TO: His Worship Mayor Michael Morden
and Members of Council
FROM: Chief Administrative Officer

MEETING DATE: May 7, 2019
FILE NO: 2013-096-RZ
MEETING: Workshop

SUBJECT: Tandem Parking Update

b) A tandem arrangement with single car garage and a driveway apron:

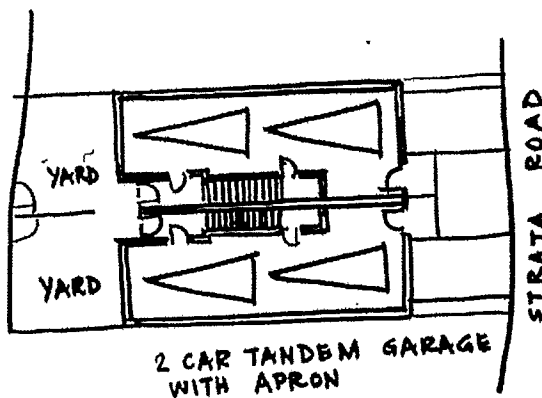
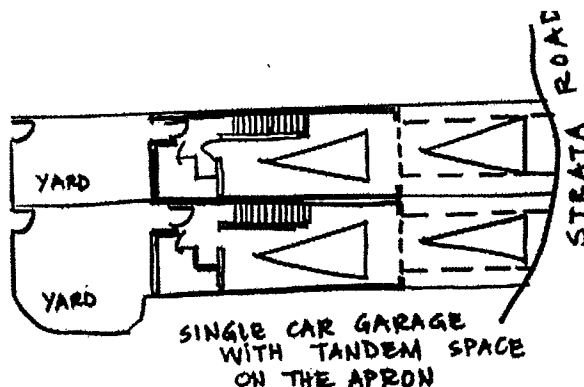
Comments: IN REALITY THIS WOULD END UP BEING A SINGLE CAR PARKING SCENARIO

- a) A two car tandem garage with a driveway apron:

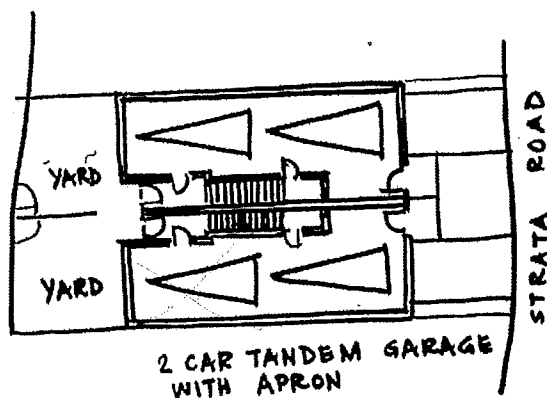
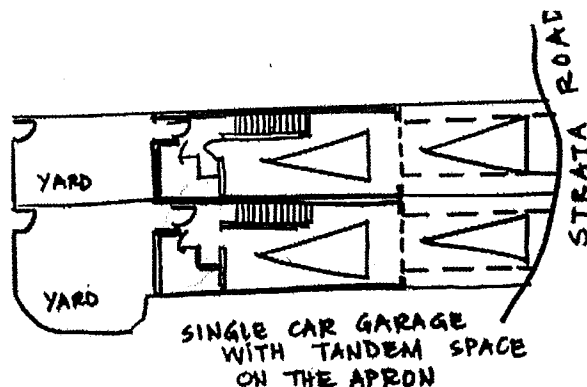
TANDEM GARAGES
ARE ONLY A STORAGE UNIT
AND PARKING FOR 1 CAR.

THIS IS A STORAGE UNIT
AND PARKING FOR 1
CAR.

- b) A tandem arrangement with single car garage and a driveway apron:

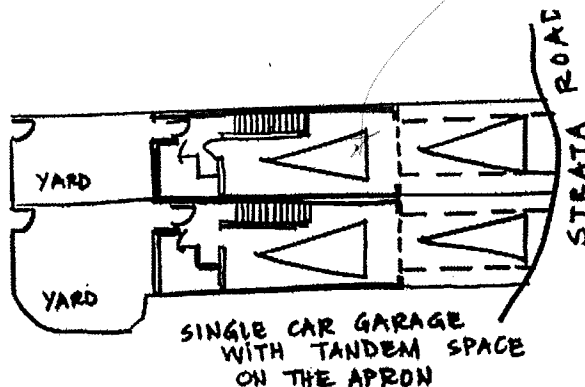
THIS IS BETTER
BUT TANDEM PARKING
SIMPLY DOES NOT WORK

a) A two car tandem garage with a driveway apron:

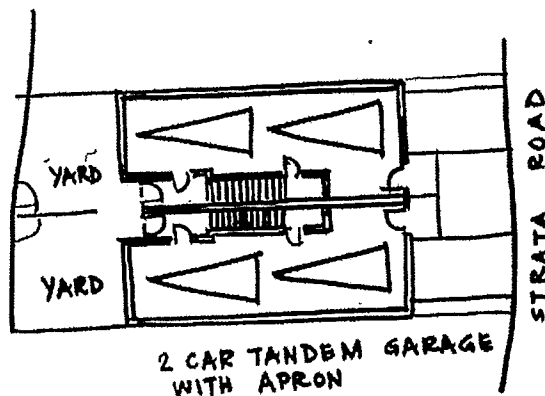
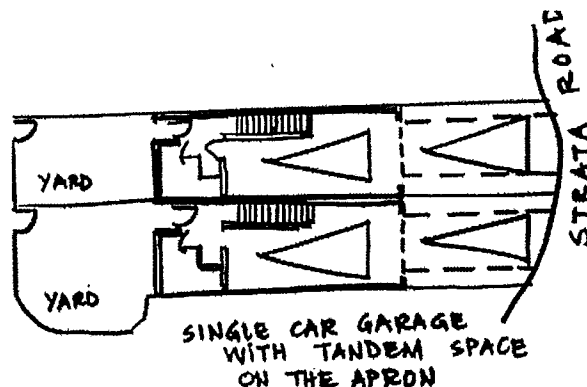
Comments: The yield for developers will be effected "too much" resulting in decreased land values for landowners.

Comments: This option is favorable for both yield and a better community. It is a more balanced approach.

a) A two car tandem garage with a driveway apron:

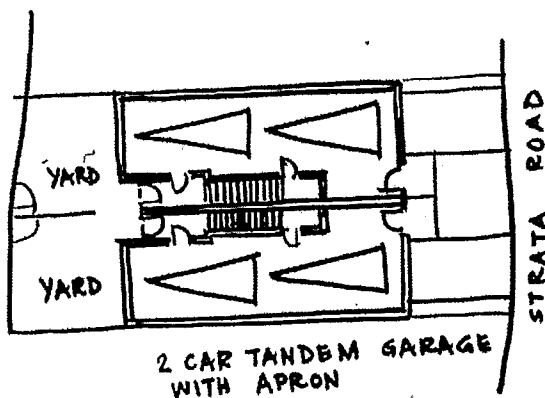
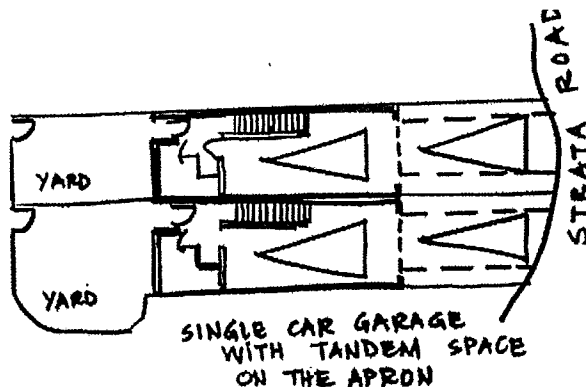
Comments: People will stop using indoor parking and use Apron for convenience.

Comments: This is more attractive form + supply higher visitor parking ratio.

b) A tandem arrangement with single car garage and a driveway apron:

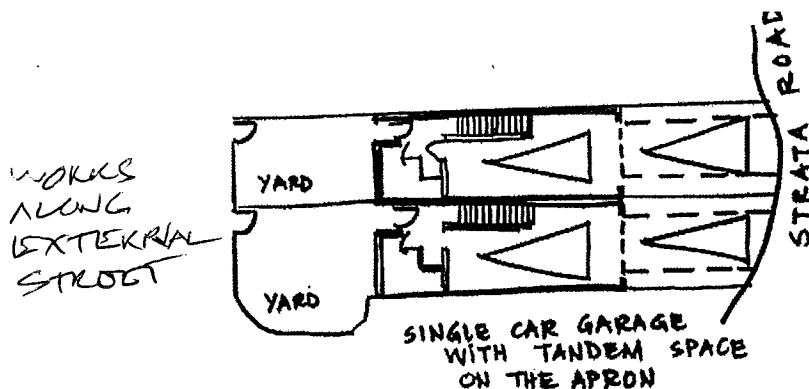
Comments: LESS EFFICIENT THAN TANDEM GARAGE W/ 6' APRON
MORE EFFICIENT THAN DOUBLE GARAGE

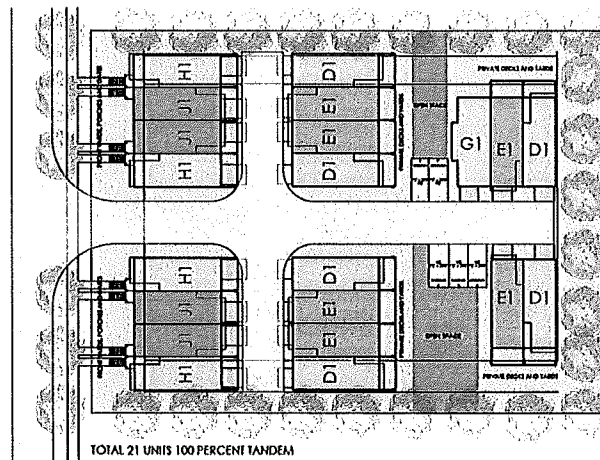
Below is a more realistic scenario utilizing the same parcel of land prepared by an experienced multi-family architect. The street oriented townhomes at the front create an attractive and interesting pedestrian oriented streetscape. Residents can meet and have conversations with neighbors or passers-by from their porches or front entry yards. This development is attractive, promotes community, walkability and eyes on the street.

2. The alternative scenarios which incorporate some side by side parking units for comparison are drawn more creatively than the original 100% tandem scenario. Unfortunately, there are no accompanying unit plans. We are not aware of a side-by-side parking unit of 1000 sq. ft. as shown in these alternate scenarios that is being sold in the market. In addition we are unsure how the larger square units shown would be designed. If these unit plans are available, we would be happy to comment on their marketability.
